# URBIS SUBMISSION TO BETTER APARTMENTS DRAFT DESIGN STANDARDS

19 SEPTEMBER 2016  
PREPARED BY URBIS WITH INPUT FROM LOCALLY RESPECTED ARCHITECTS

Figure 2 Windows Case Study

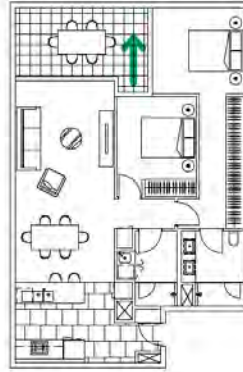
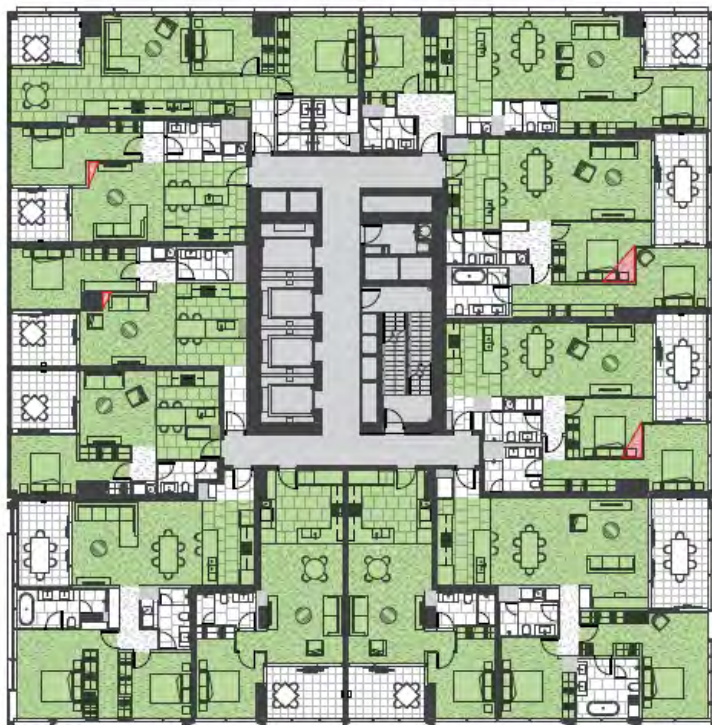
**Figure 2** shows differently configured apartment layouts that demonstrate how well dimensioned and appointed apartments would not meet the draft standard by would achieve the outcome sought by this requirement.

Snorkel arrangement, although shallow, would likely not satisfy the DDS standard. It is unclear if this configuration would satisfy the objective.

/ Unclear if this would be acceptable under proposed standards, common in NSW to approve minor variations to the standards.

/ Satisfactory arrangement, irregular balcony extension  
/ Potential for living room to be compromised in favour of bedroom

/ Sliding door provides additional views and flexibility

- A habitable room should have a window in an external wall of the building ~~that is visible from any point in the room.~~
- Any 'saddleback' windows may only be applied in bedrooms or studies (not main living areas) and must have a minimum depth-to-width-ratio of 2:1 taking into account the outer edge of any roof structure if the window is to a covered balcony.

Figure 3 Natural Ventilation Case Study

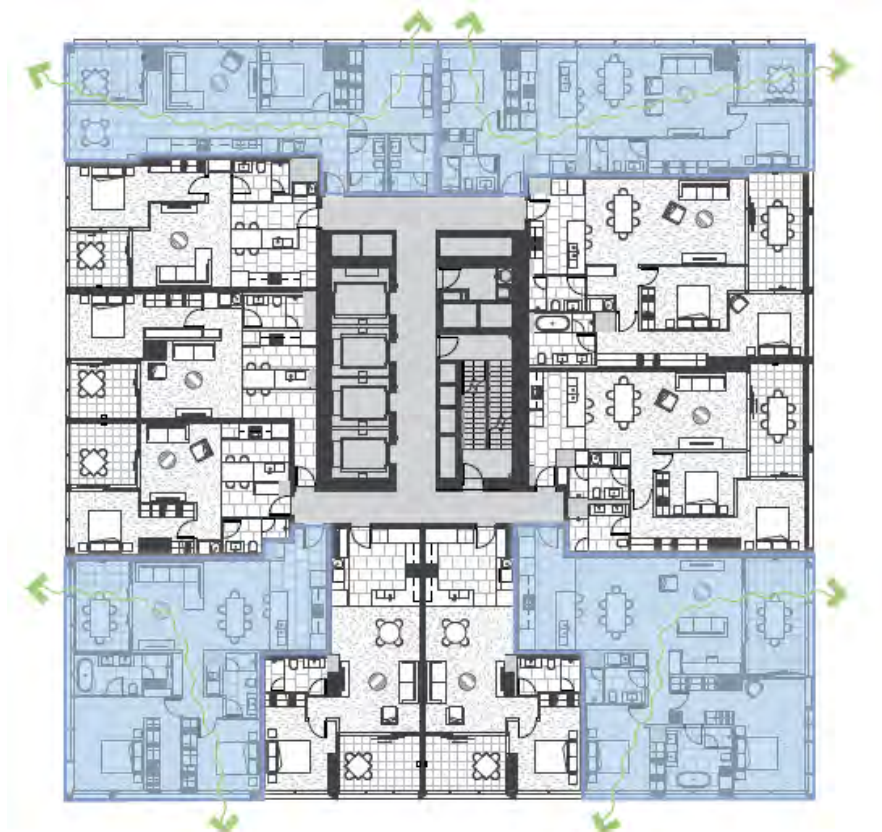
Figure 3 demonstrates that on a typical block it will be very difficult to meet the cross ventilation standard of 60% and requires apartments to have a dual aspect.

Not enough dwellings provide ventilation – 33% vs. 60% requirement from the DDS.

At least 640 per cent of dwellings with a finished floor level less than 35 metres in height should be naturally cross-ventilated. The length of breeze path through the dwelling should be a maximum of 15 metres (as measured between openable windows and doors).

**FUNCTIONAL TWO BEDROOM 'SADDLEBACK' APARTMENT PLAN**

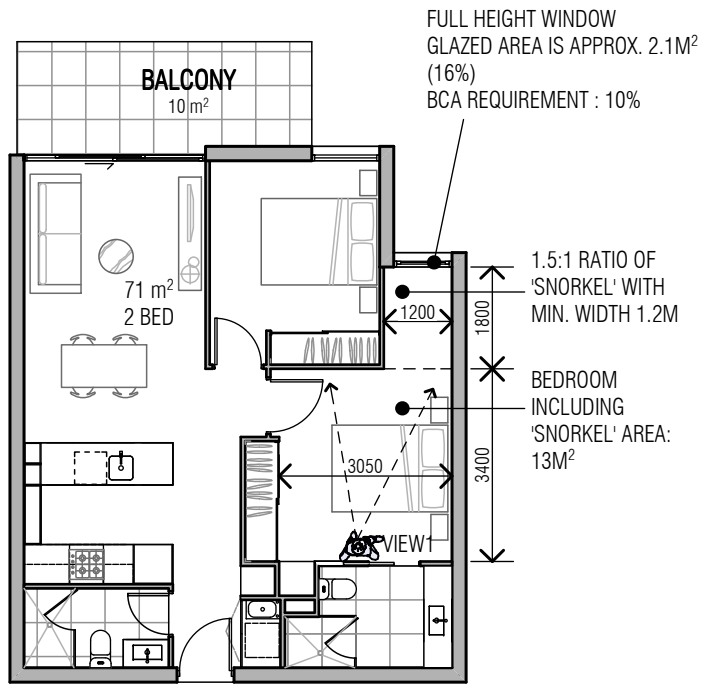
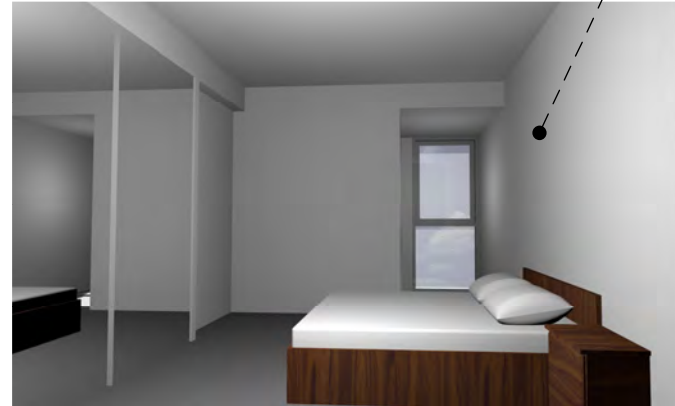
GREATER SENSE OF SPACE DUE TO  
EXTENDED WALL BEHIND BED COMPARED  
TO CONVENTIONAL BEDROOM PLAN

WINDOW IS VISIBLE FROM USABLE AREA OF BEDROOM (BED, ENSUITE)

**POOR EXAMPLE OF 'SADDLEBACK' BEDROOM PLAN**

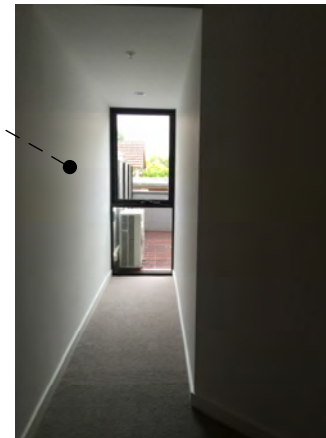
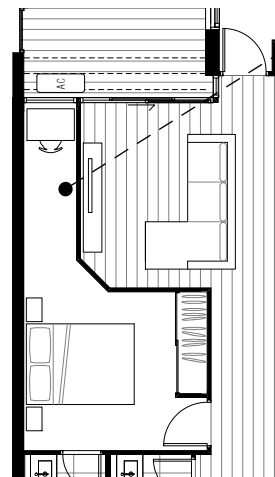
'SNORKEL' IS TOO LONG AND NARROW  
AND WINDOW TOO DISTANT FROM  
USABLE AREA OF BEDROOM

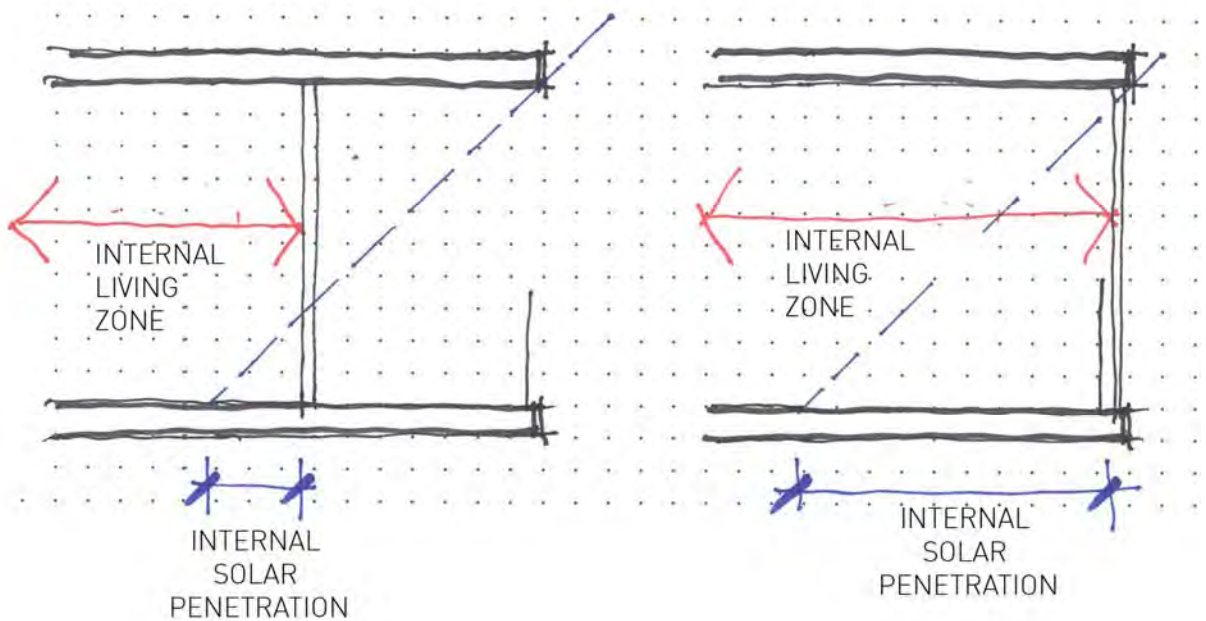
The diagrams below show how far light will penetrate within a typical living space in both a traditional balcony apartment compared to the proposed design proposal.

Reduced solar penetration with traditional apartment

Increased solar penetration with proposed design

**For a typical north facing apartment the dwelling will experience at all times a greater ingress of light into the living spaces.**
